Toronto and Region Conservation Authority and the City of Brampton

# **DOWNTOWN BRAMPTON FLOOD PROTECTION**

*Addendum to the Environmental Study Report*

Figure 1 CN Crossing Alternative Approved in ESR

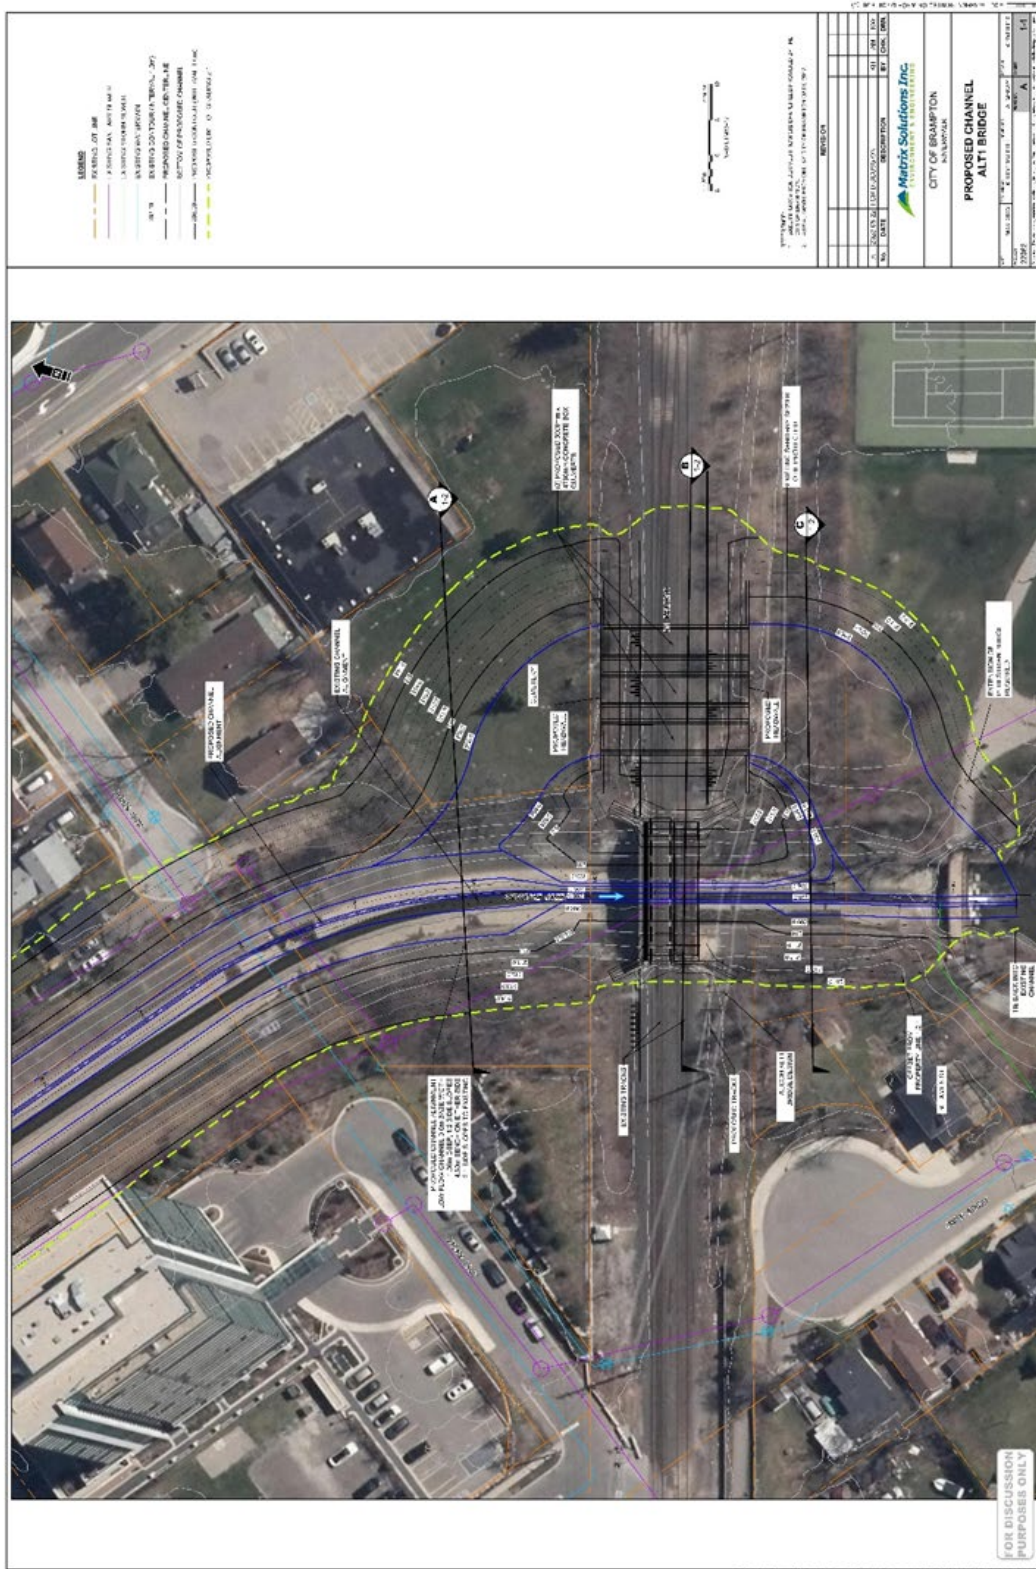
The EA identified the CN rail crossing as a significant constraint for the project and proposed a solution for providing additional conveyance needed for passing the Regulatory storm via the installation of three culverts located to the east of the existing crossing (see Figure 1). However, this alternative resulted in significant impacts on the St Mary's Heritage Cemetery likely resulting in the relocation of graves. The question of how to provide for the flood conveyance at the CN crossing was to be further investigated during detailed design.

Alternative 3 was chosen as the new preferred alternative to provide flood conveyance for Etobicoke Creek at the CN crossing. This alternative includes 3 box culverts on the west side of Etobicoke Creek. The proposed grading limit was kept at a 2:1 side slope but could be potentially steepened with structural engineering solutions to lessen impacts to the John Street and James Street cul-de-sacs. The slope stability assessment is being undertaken as part of detailed design. This alternative avoids impact to the cemetery however it will impact the house and property at 30 James Street and the cul-de-sacs. While both the cemetery and the house at 30 James Street have heritage value, the relocation of the cemetery has more
